1 ADDENDUM #3

Project Title: Holland College Summerside Waterfront - GreenBuild Trade Expansion
98 Water Street, Summerside PE

Project Title: Holland College Summerside Waterfront - GreenBuild Trade Expansion
98 Water Street, Summerside PE

1
MSK003

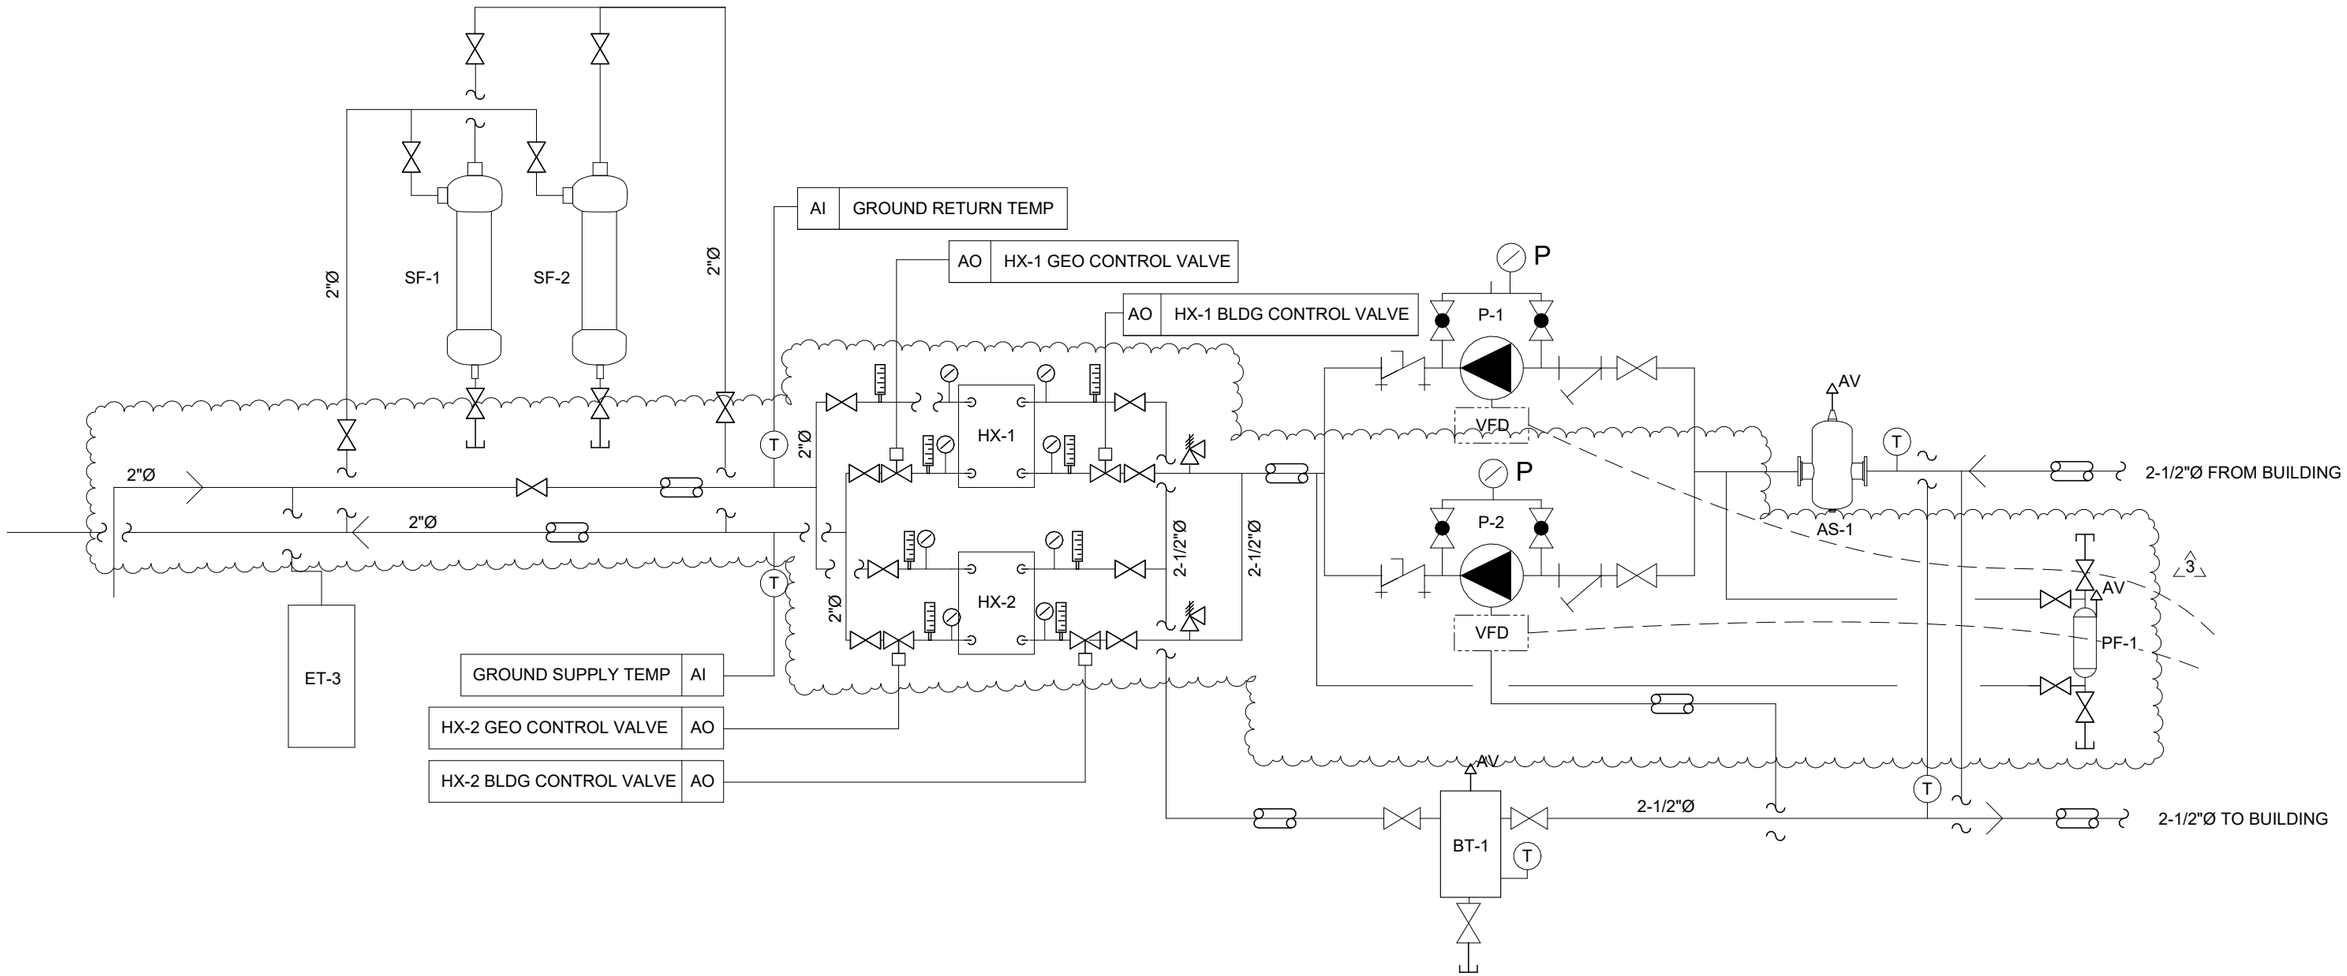
.13 Drawing M202 – Geothermal PID:
- .1 Revise Geothermal PID as per Detail 1/MSK003.
